# UNITED STATES PATENT AND TRADEMARK OFFICE

APPLICATION NO.	FILING DATE	FIRST NAMED INVENTOR	ATTORNEY DOCKET NO.	CONFIRMATION NO.
10/600,112	06/20/2003	Stephan Karl Barsun	200209739-1	7760

<b>Office Action Summary</b>	<b>Application No.</b> 10/600,112	<b>Applicant(s)</b> BARSUN ET AL.	
	<b>Examiner</b> Tho v. Duong	<b>Art Unit</b> 3743

### **DETAILED ACTION**

Figure B: the modified figure corresponds to figure 2 with curved fins shown

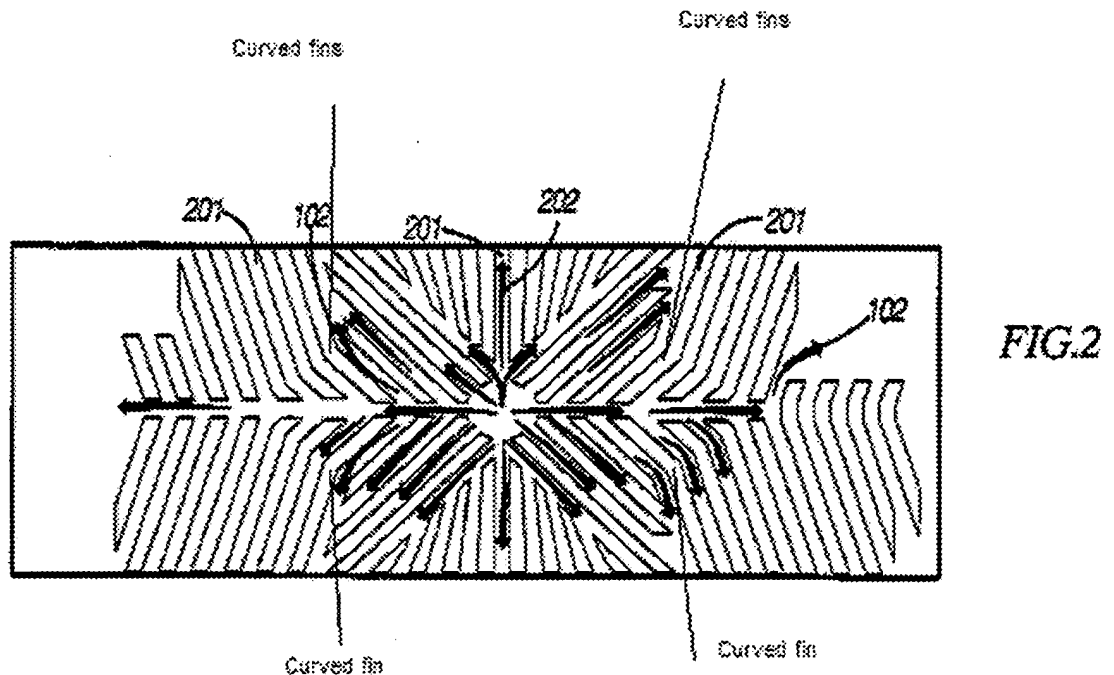
Claims 1-5,8-11,13,14,16 and 18-19 are rejected under 35 U.S.C. 102(b) as being anticipated by Wildmayer (US 5,582,240). Wildmayer discloses (figures 1 and 2) a device for removing heat from an electronic component, comprising a heat sink (200) adapted to couple to the electronic component and conduct heat therefrom; a plurality of fins being integral part of the heat sink to transfer heat into a cooling air, wherein the fins are oriented at an obtuse angle with respect to a plurality of flow streams (102,201) across the fins and wherein each flow stream of the plurality follows a unique direction. Wildmayer further discloses (figure 2) that the space between most of the fins is substantially even and the flow stream is following in all 4

perpendicular directions. Regarding claims 2, 9, 13 and 18, Wildmayer discloses (figure B as bellow) the small angle of curved fins is to gradually change the direction of the airflow.

Figure A: The modified figure corresponds to figure 4 with flow of stream air shown.

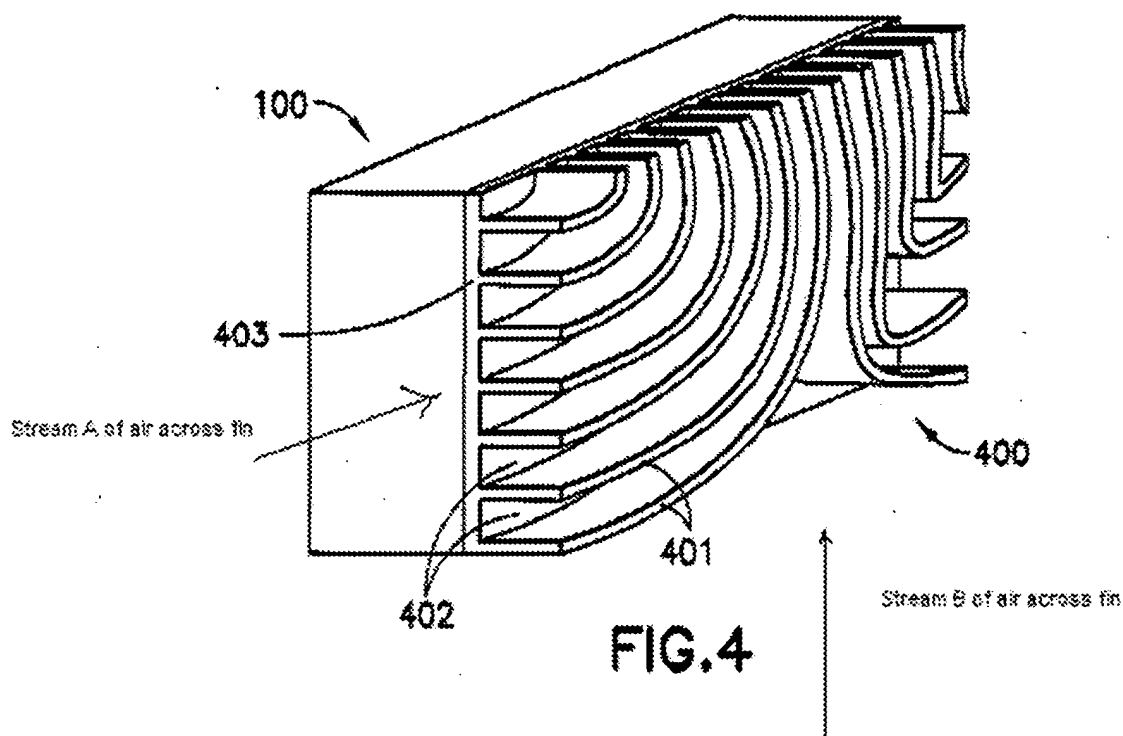
Claims 1-5,8-11,13,14,16 and 18-19 are rejected under 35 U.S.C. 102(b) as anticipated by or, in the alternative, under 35 U.S.C. 103(a) as obvious over Suntio (US 6,313,399). Suntio discloses (figures 3, 4 and figure A as follow) a device for removing heat from an electronic component (100), comprising a heat sink (300,400) adapted to couple to the electronic component and conduct heat therefrom; a plurality of curved fins (401) being integral part of the heat sink to transfer heat into a cooling air, wherein the fins (401) are oriented at an obtuse angle with respect to a plurality of flow streams across the fins and wherein each flow stream of the plurality follows a unique direction in channels (402) in a gradual change of direction. Suntio further discloses (column 2, lines 51-56) that the wide gap at the lower edge and/or side of the heat sink suck lot of air into the device. Since the lower edge and the side edge are orthogonal to each other, it would have been obvious to one of having ordinary skill in the art to see that the flow streams approaching each edge is substantially orthogonal to each other. As illustrated in figure A, the fluid streams (A) and (B) are oriented substantially orthogonal to each other. Regarding claims 1, 9 and 14, Suntio does not disclose that the space (402) is even through out

the flow channels but the space (402) between most of the fin (401) is substantially even at one side of the edge.
